Access Compliance Report

Public Rights-of-Way

(Curb Ramps)

Intersection ID: 17009	Main Street: N_WENDOVER_RD	Cross Street: RANDOLPH_RD	Location: N
ADA ID: AC82C9AF33A1	Ramp Type: Perp	Initial Pass/Fail: Fail	Overall Compliance: No
Severity Score: 46.25			
Codes/Mitigation Info/Possible Solution		Field Measurements/Component Compliance

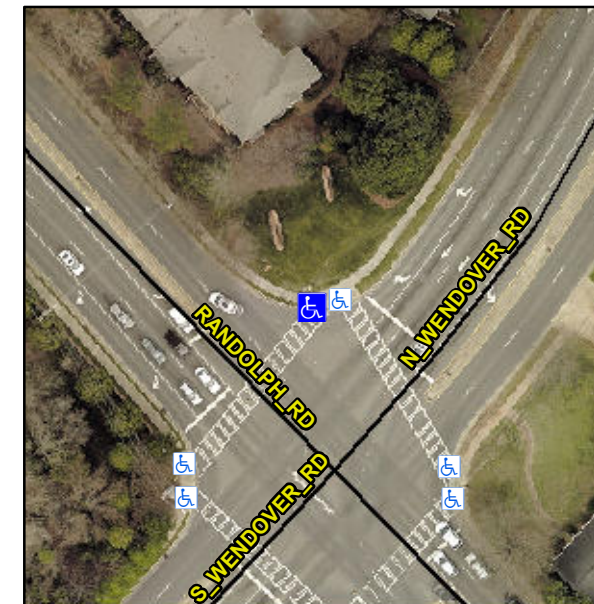
Not Found, R304.5.1, R304.2.2, R304.5.3

Compliance	Description	Data	Compliance	Description	Data
N/A	Ramp Length (in)	92.0	No	Ramp Slope (%)	9.5
No	Ramp Width (in)	46.0	No	Ramp XSlope (%)	7.8
N/A	Flare Type LT	N/A	N/A	Flare Type RT	N/A
N/A	Flare Slope LT (%)	N/A	N/A	Flare Slope RT (%)	N/A
N/A	Flare Traversable LT?	N/A	N/A	Flare Traversable RT?	N/A
N/A	Landing Length (in)	N/A	N/A	DWS Provided?	N/A
N/A	Landing Width (in)	N/A	N/A	DWS Contrast?	N/A
N/A	Landing Slope (%)	N/A	N/A	DWS Length (in)	N/A
N/A	Landing X Slope (%)	N/A	N/A	DWS Full Width?	N/A
N/A	Landing Curb? (Y/N)	N/A	N/A	DWS Offset (in)	N/A
N/A	Shared Landing?	N/A			
N/A	Gutter Ponding?	N/A	N/A	Gutter Slope (%)	N/A
N/A	Gutter Lip Ht (in)	N/A	N/A	Gutter X Slope (%)	N/A
N/A	Painted X Walk1?	Yes	N/A	Painted X Walk2?	N/A
	X Walk 1 Direction	To SW		X Walk 2 Direction	N/A
N/A	X Walk 1 Width (in)	108.0	N/A	X Walk 2 Width (in)	N/A
	X Walk 1 Slope (%)	2.4		X Walk 2 Slope (%)	N/A
	X Walk 1 X Slope (%)	5.8		X Walk 2 X Slope (%)	N/A

N/A	Ramp inside XWalk1?	Yes	N/A	Ramp inside XWalk2?	N/A
	Road Slope (%)	N/A	N/A	Clear Space?	N/A
	Road X Slope (%)	N/A	N/A	Clear Space to XWalk (in)	N/A
N/A	Any Obstructions?	N/A	N/A	Storm Grate/Utility Hazard?	N/A
	Obstruction Type			Storm Grate/Utility Type	
		N/A			N/A
		Yes		Surface Condition? (G/P)	Good

Remove & Replace Entire Ramp.
